This document is intended to fulfil the action assigned to Mark Hawes in the Open Floor Hearing on the 22<sup>nd</sup> February. The action involves responding to the Applicant response submitted via REP3-026 Highways England Deadline 3 Submission - 7.15 Applicant's Responses to Written Representation (table 1-6). Due to the inclusion of large pictures this document has been split into two parts. This document is part 2 and is intended to be read after part 1.

#### Follow-up response to deadline 3 comments from the Applicant - Reference 6

#### View to the South of the property and the route of the new PMA

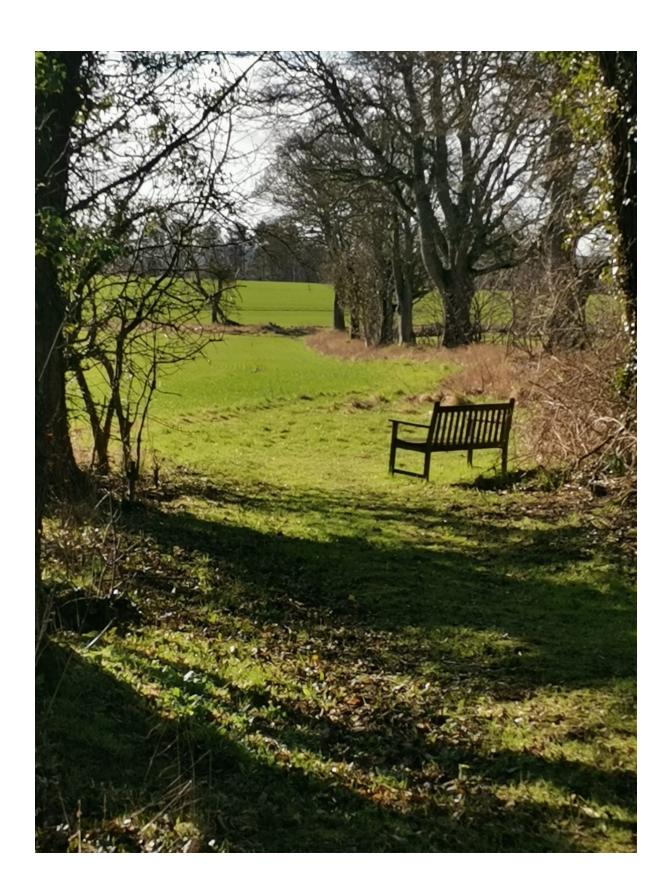
The following photograph is taken from the South East corner of the property. This view will change dramatically when the new PMA is constructed. The intended route of the road is along the trees and then across the immediate foreground. This is one of our favourite spots for relaxing and enjoying the views.
